Water and the Tenas Coal Project: Current status and potential impacts to Wet'suwet'en interests

Prepared for the
Office of the Wet'suwet'en Natural Resource Department
by Allison Oliver, Ph.D., Skeena Fisheries Commission

May 1, 2022

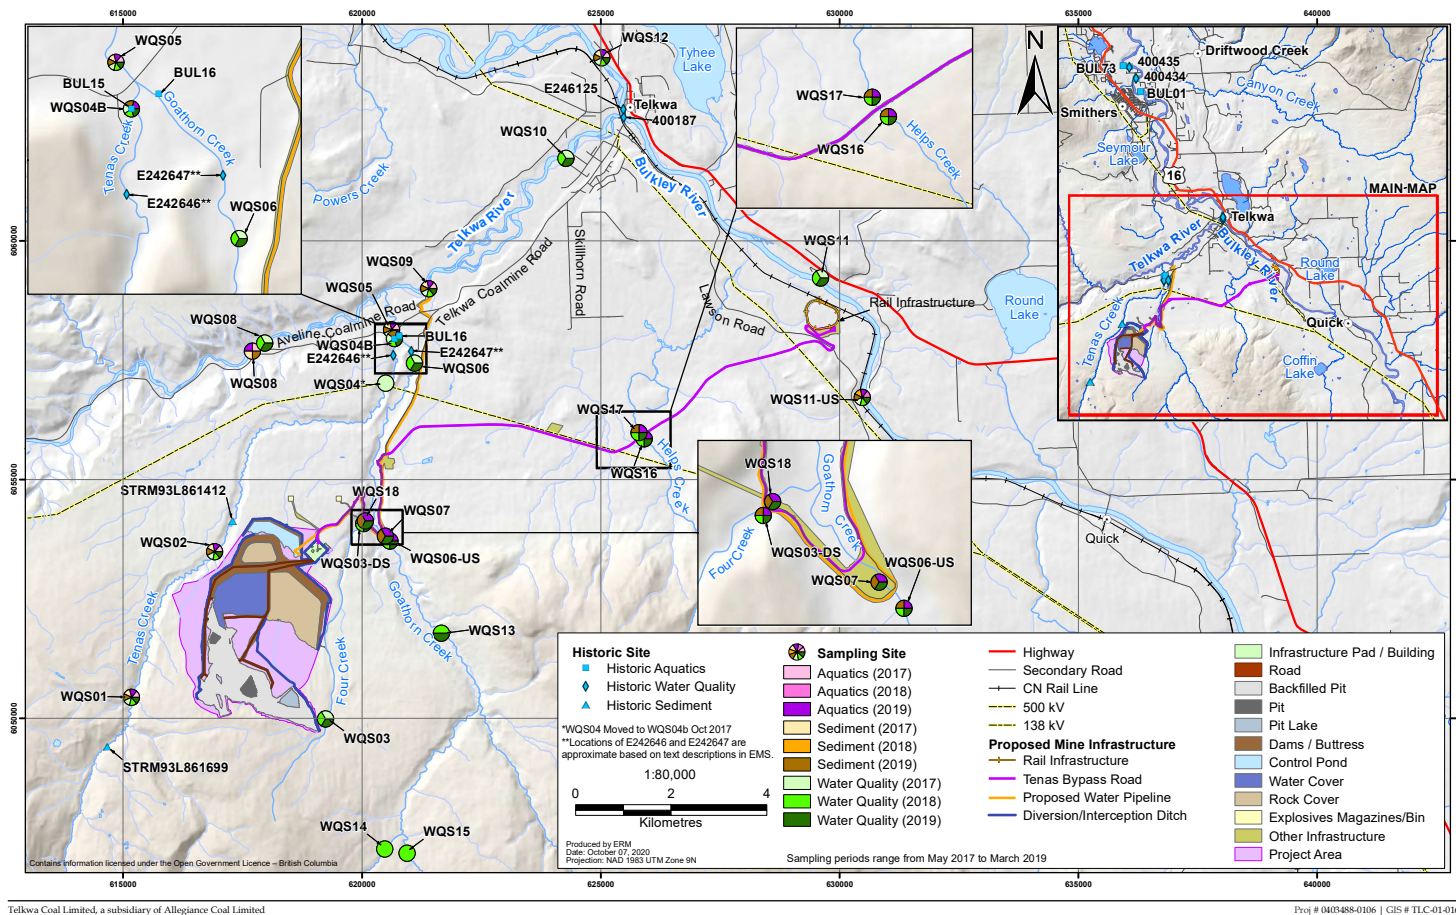
- The proponent should provide better maps of the Project area that clearly show locations of specific discharge points to the environment along with locations of site facilities and management ponds, and in conjunction with locations of water quality and aquatic resources sampling sites. Many of the maps are poor resolution and include undefined information.
- The Project needs to provide specific locations for water discharges from management ponds. These are not clearly shown on the map and no coordinates are given in the Project application.
- Existing water monitoring locations are located a substantial distance downstream from (estimated) planned discharge locations. Additional water sampling sites for baseline determination and future monitoring should be established proximal to these discharge points,
